EGG-SSDC-5381

March 1981

HUMAN FACTORS EVALUATION OF
THE ENGINEERING TEST REACTOR
CONTROL ROOM

Figure 23. Example of poor functional grouping of degassing tank indicators. (People point to different, but functionally related displays.)

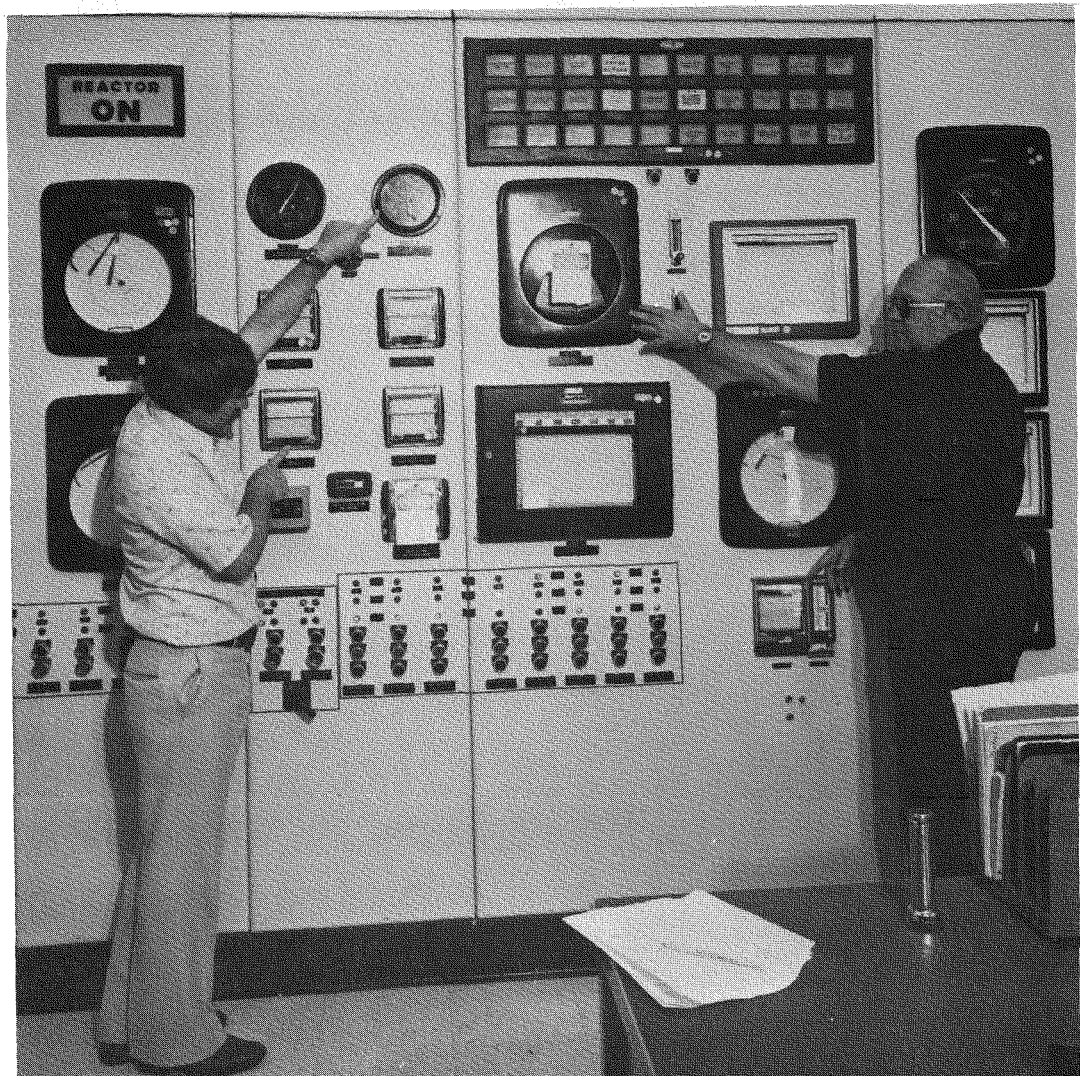
1. Instruments, such as emergency flow rate, Channel A, B, and C, are widely separated (over 12 ft) on the panel (see Figure 22). It usually makes good design sense to group instruments with common or similar functions relatively close to each other; then surround the area with demarcation lines which visually separate common instruments from other non-related instruments (see Figure 23 and 24). Other sets of instruments that could be rearranged for better functional grouping include:

Figure 25. Hypothetical Display Layout which conforms to Human Factors Design Principles.

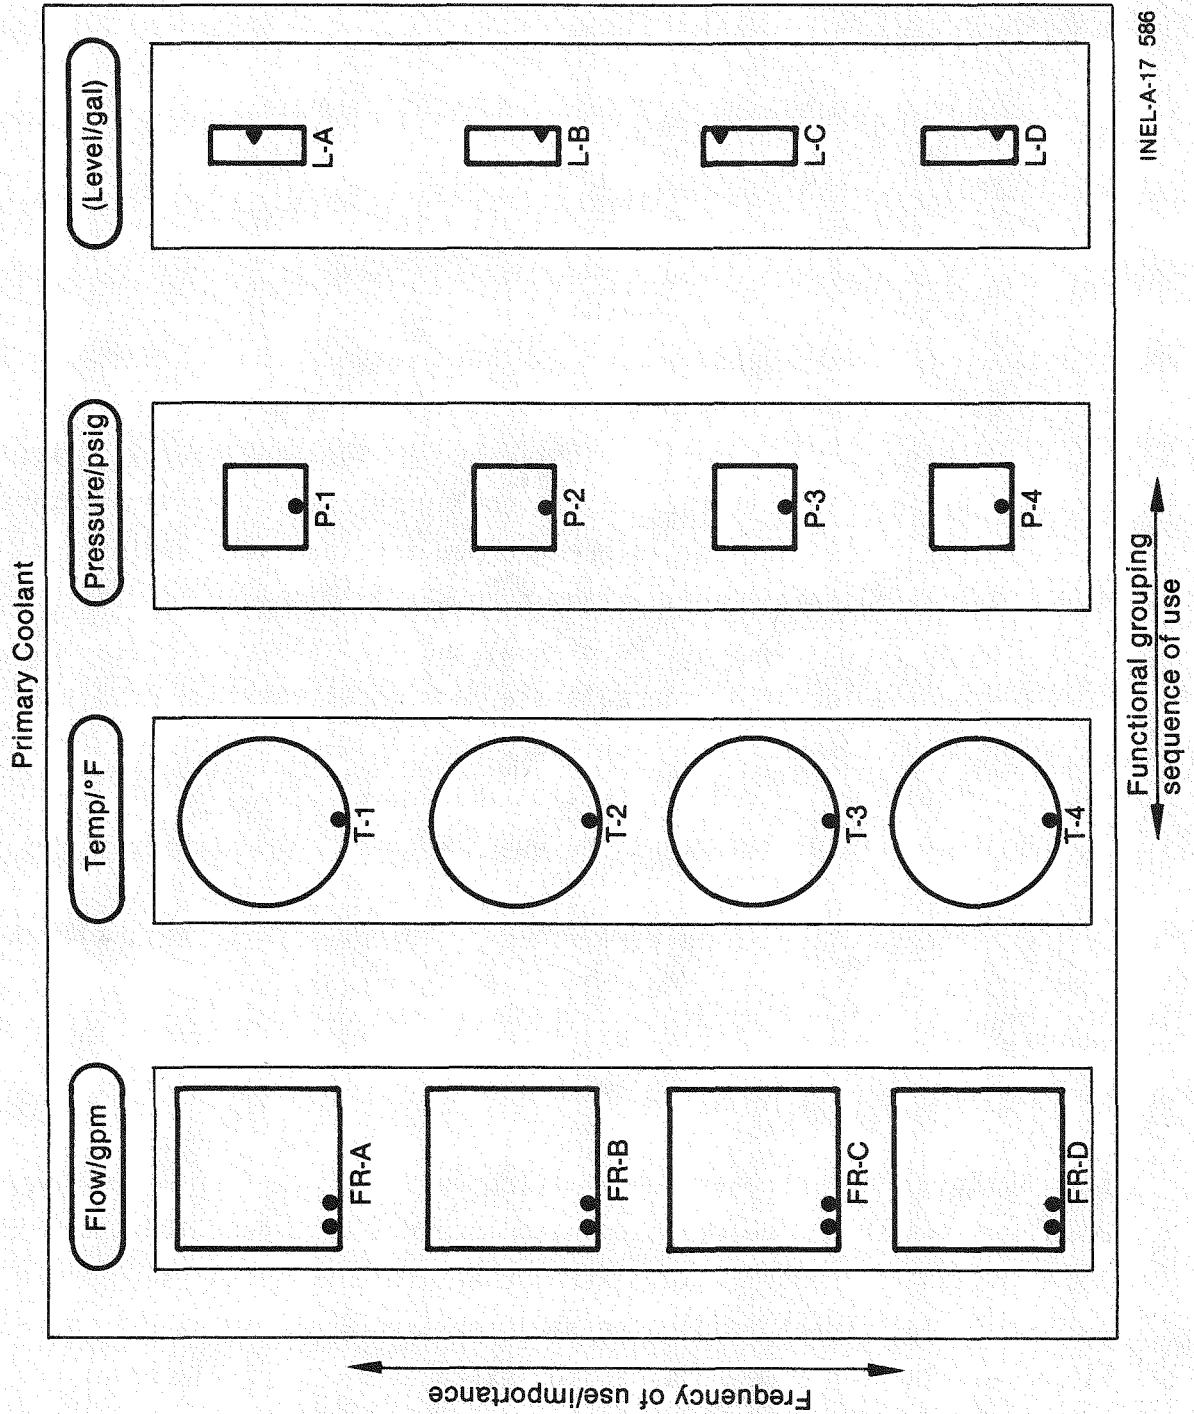
1. Figure 25 shows an example of how the primary coolant subsystem in the Process Control Room could be reconfigured to more adequately conform to MIL-STD-1472-B. Note that all functionally related flow, temperature, pressure, and level indicators are grouped together with appropriate labels and units of measure. In addition, each set of displays is configured according to function, sequence of use, and importance. For example, displays on the top of the console are more important than displays situated on the lower portion of the panel. Likewise, those instruments located on the left would hypothetically be used first, and those displays on the right side of the panel are accessed last when logging data.

- Figure 26. A. Example of visual interference caused by panel separation lines which intersect functional grouping demarkation lines.
- B. Example of dual-scale function indicator (TRCA-4-1). These types of indicators should be replaced with single-function displays to minimize errors in reading.

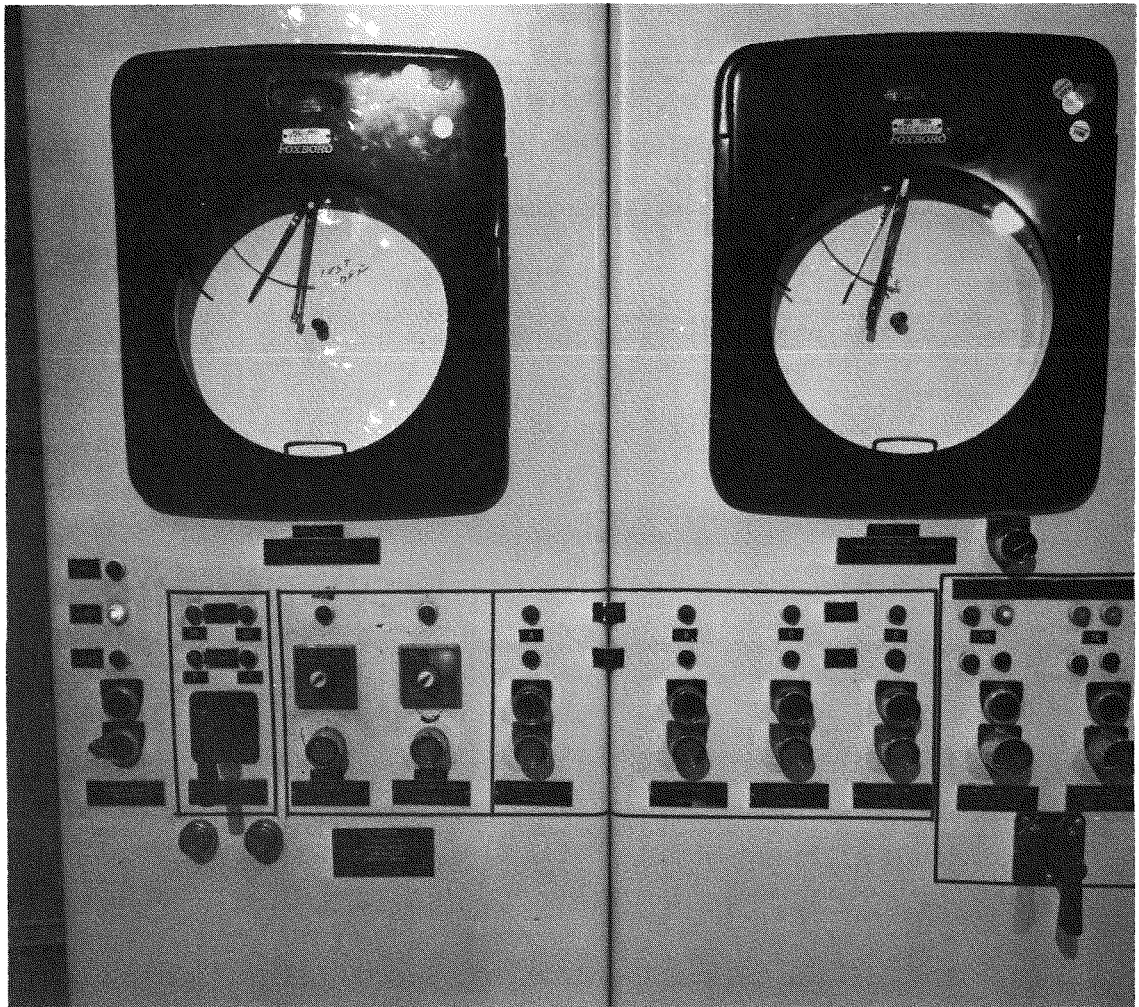
2. Panel separation lines were found to interfere with demarcation strips (see Figure 26). If possible, all panel separation sections should be unobtrusive to the eye. Flat panel surfaces are preferred, with no sloping at the edges to create obtrusive panel lines.

Figure 27. Example of a flow indicator (F1.4-10) showing a scale range of 0 to 300 gpm; the actual flow rates never exceeds 150 gpm. This instrument is over scaled by a factor of 2 which causes degraded precision in interpolation and reading.

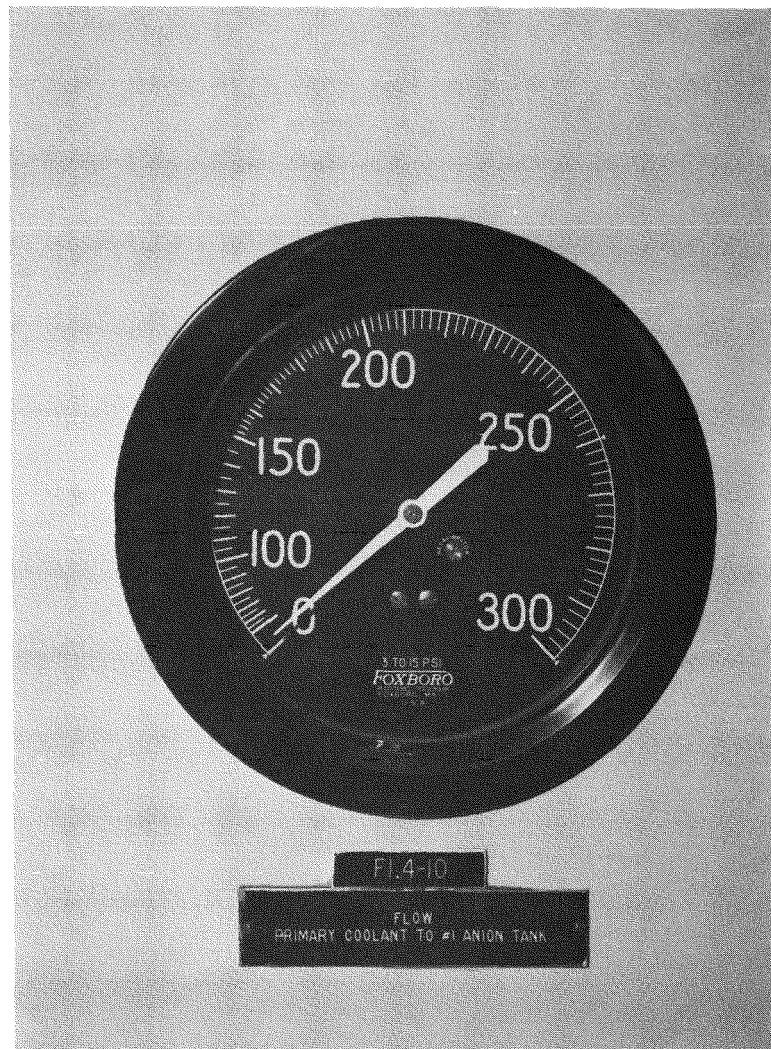
5. Readings taken with FI.4-10 (flow indicator) never move outside the range of 0 to 50 gpm (see Figure 27). However, the indicator scales indicate 0 to 300 gpm. Due to the wide range of scaled values on this instrument, it is sometimes difficult to determine values falling between 0 and 150 gpm. It is recommended that this gage be replaced with another instrument which reads between the range of 0 and 160 gpm, and that the 0-300 gpm indicator be used only during core clean-up.

Figure 28. Annunciator Acknowledge and Reset Control. Notice the absence of labels.

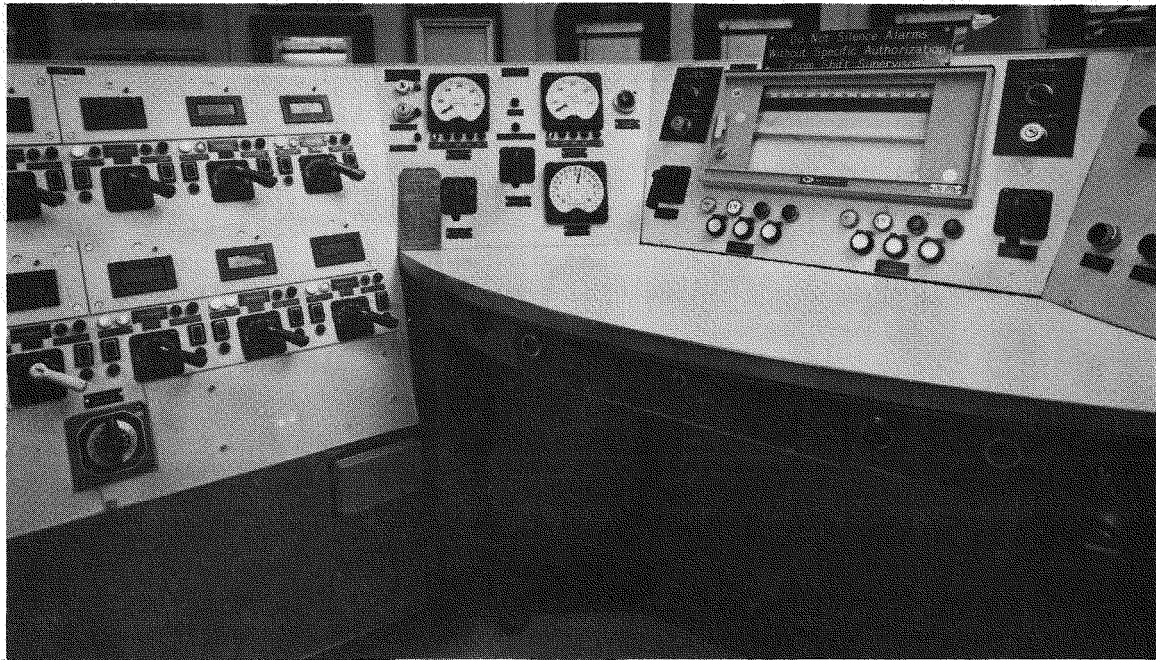
2. The annunciator acknowledge and reset buttons had no label to indicate the function of individual buttons. It is recommended that these components be clearly labeled (see Figure 28).

Figure 29. Example of a display which carries highly visible manufacturers label.

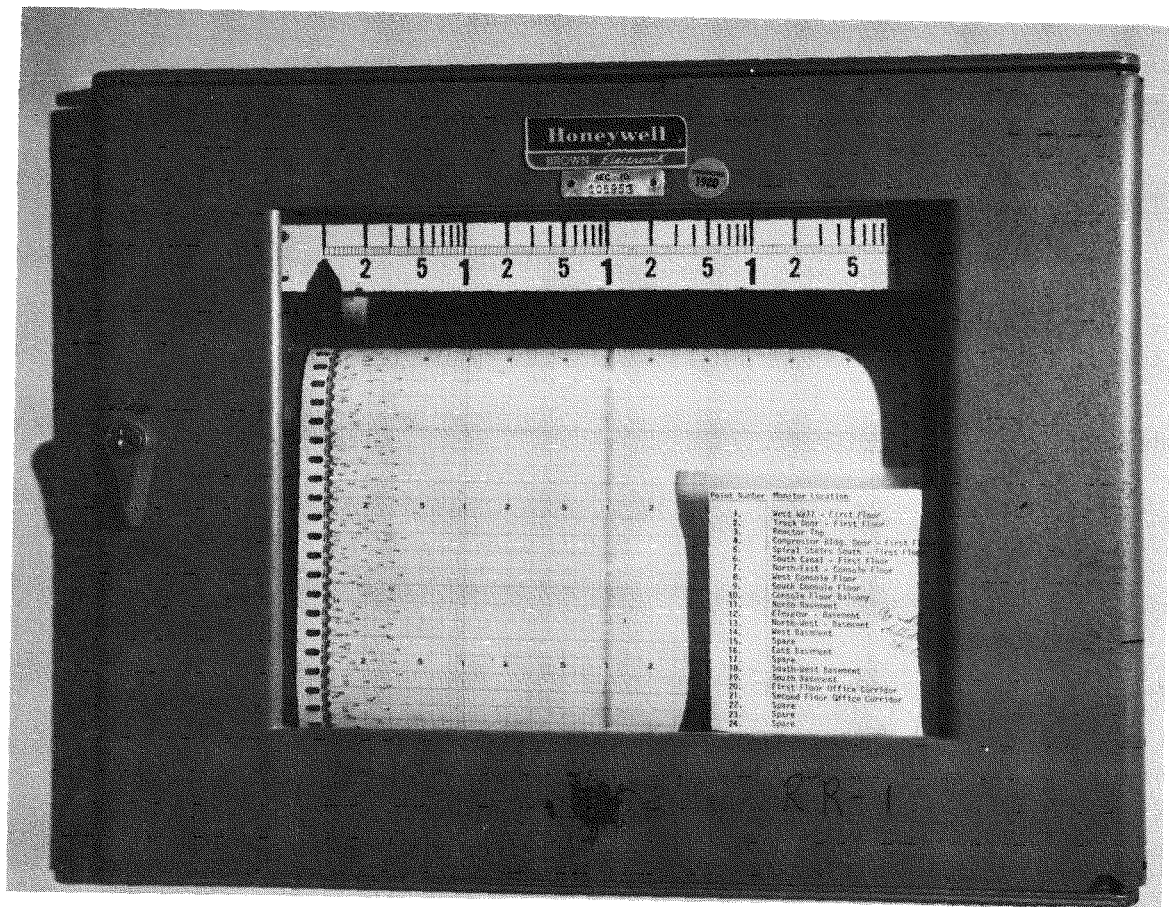
3. MIL-STD-1472-B (9.5.5.3.3.) specifically states that irrelevant information, e.g., trade names, should be omitted from display equipment. Approximately 75% of all meter displays contained the manufacturers' name and model number on the front display panels (see Figure 29). In many instances, the letters comprising the manufacturers' name were more legible than the function label.

Figure 30. Example of very important primary cooling system valves P_{11} and P_{12} which failed to be differentially or specially treated from other less important valves, requiring more visual search and discrimination time from operators. The separation line also causes some operator confusion.

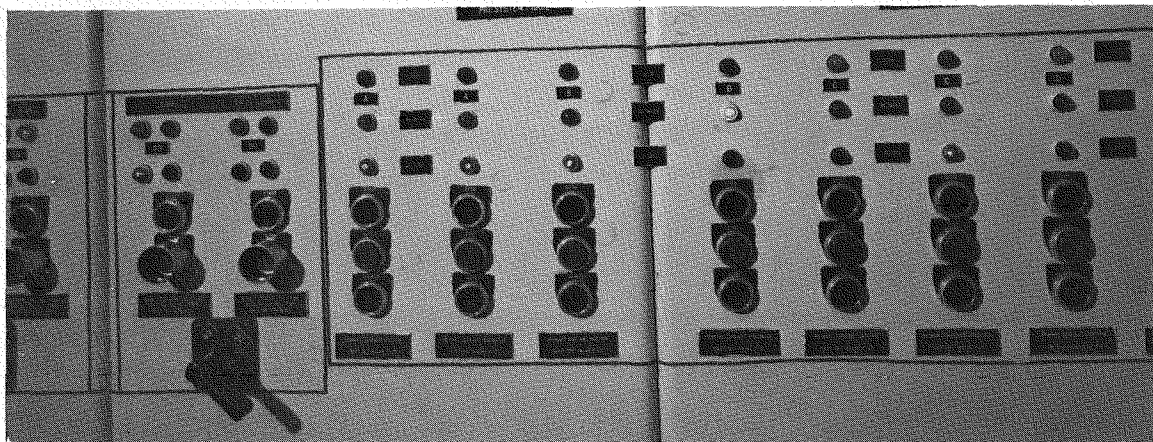
The most important controls in the Process Control Room were not labeled or marked in a significantly different manner so as to easily identify the dimension of relative importance, e.g., PCS Valves P11, P12, primary pumps, emergency and shutdown pumps (see Figure 30). Furthermore, the following components were not functionally labeled:
